# DEVELOPMENT APPLICATION ASSESSMENT

## Bondi Junction Centre development

<b>Application number</b>	DA-81/2013
<b>Site address</b>	241-247 Oxford Street, and 2 and 2A Waverley Street, Bondi Junction
<b>Proposal</b>	Demolition of existing buildings, construction of a mixed use building with basement car park. The proposal includes a Voluntary Planning Agreement.
<b>Date of lodgement</b>	15 March 2013
<b>Owner</b>	Sleek Pty Ltd and Jevorette Pty Ltd
<b>Applicant</b>	Leighton Properties Pty Ltd
<b>Submissions</b>	Original Scheme - 20 submissions, Amended Scheme - 3 submissions
<b>Cost of works</b>	\$47,670,320.00
<b>Issues</b>	Setback of tower, overshadowing impacts, internal amenity, building configuration.
<b>Recommendation</b>	<b>That the application be REFUSED</b>

**Figure 1: Shadow 9am - Proposed Building**

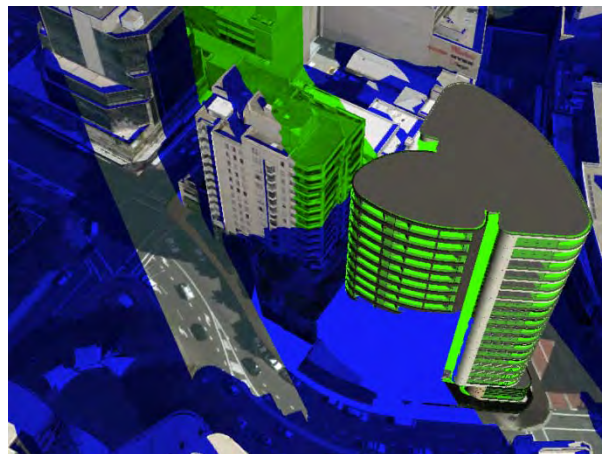
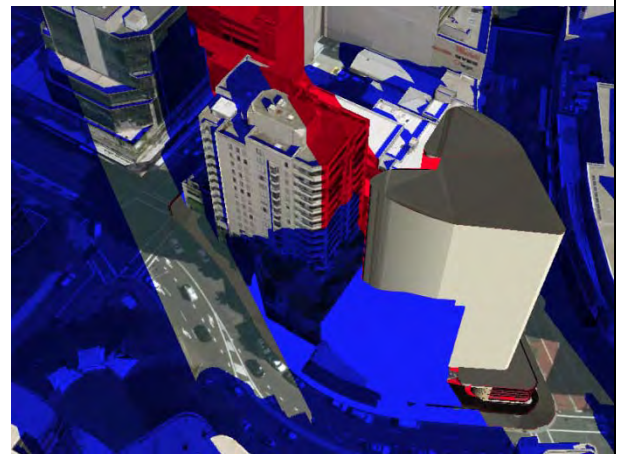
A 3D analysis indicates that the a 4m tower setback from the podium would afford better solar access to the worst effect apartments on the north east corner of the Stanford building. The proposal would result in those apartments on the north east corner of the Stanford building would only receive 1 hour of direct sunlight to the balconies at 2pm. See diagram below.

Overall, the shadow analysis reveals that the impact of 8m breach in height will not reduce the solar access to those effected apartments to less than 2 hours of sunlight as required in the Residential Flat Design Code for high density areas. Improvement of overshadowing

however demonstrated when the profile of the tower is reduced and made more slender by providing a 4m setback from the podium to the tower.
